| CHECKED <i>[Signature]</i> | APPROVED <i>[Signature]</i> | DRAWING NO. DSI 9253 | REV. B SHEET 1 OF 1 |
| DATE 05.10.14 | | TITLE 206 A/B FLOAT STEP MOD. KIT | SCALE NTS |

DART SERVICE INSTRUCTION

TO AMEND INSTALLATION DRAWING D206-628 REV. D/E

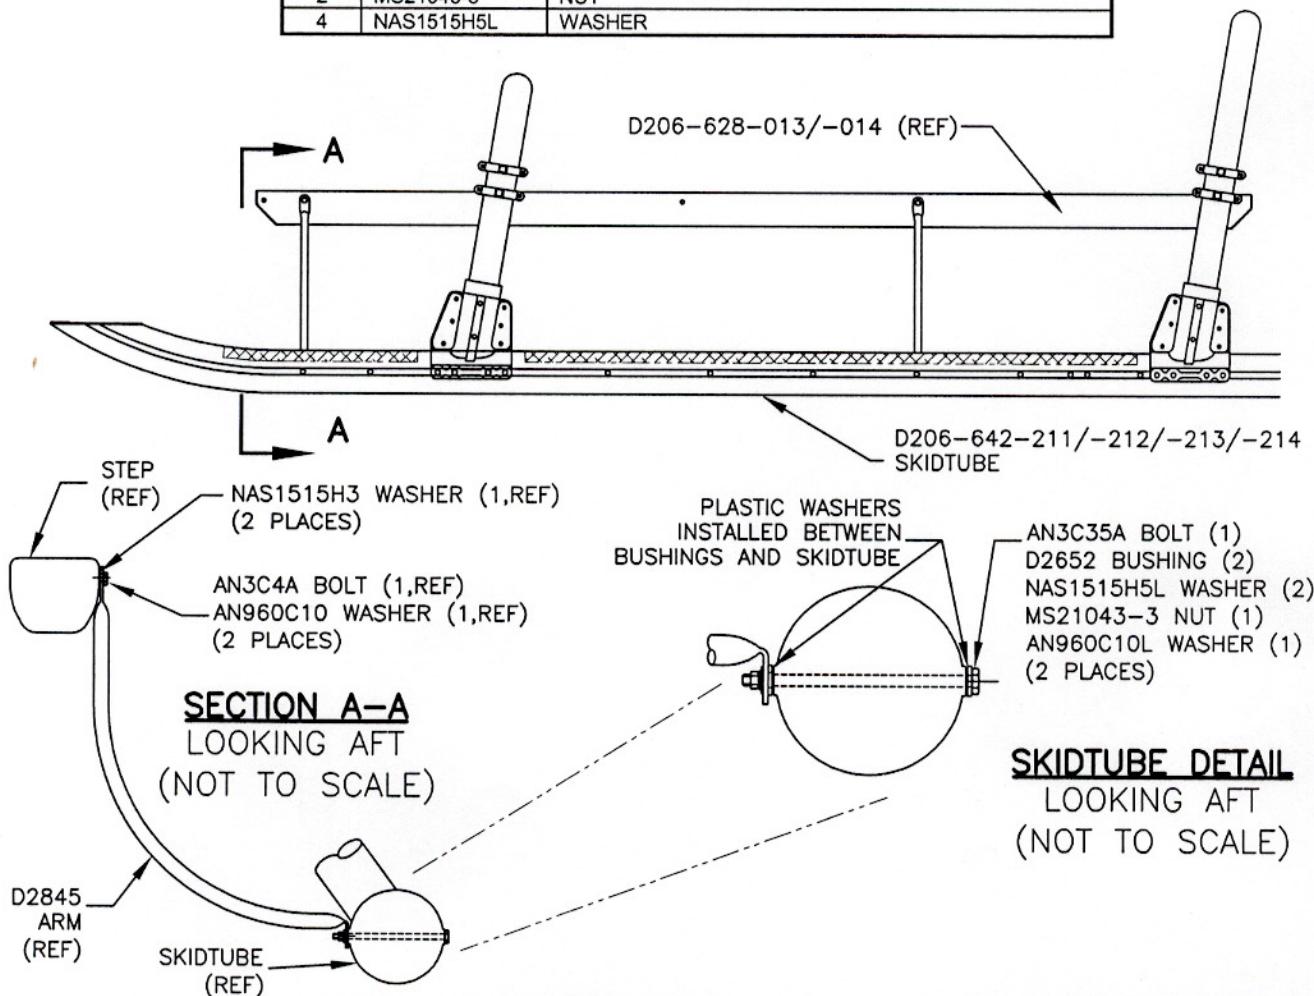
To make the D206-628-013/-014 Float Steps compatible with both the Dart D206-642-211/-212/-213/-214 Skidtubes and the Dart D206-590-011/-021 Kwik Float Emergency Floatation System. Install D2845 Arms between step and skidtube as shown
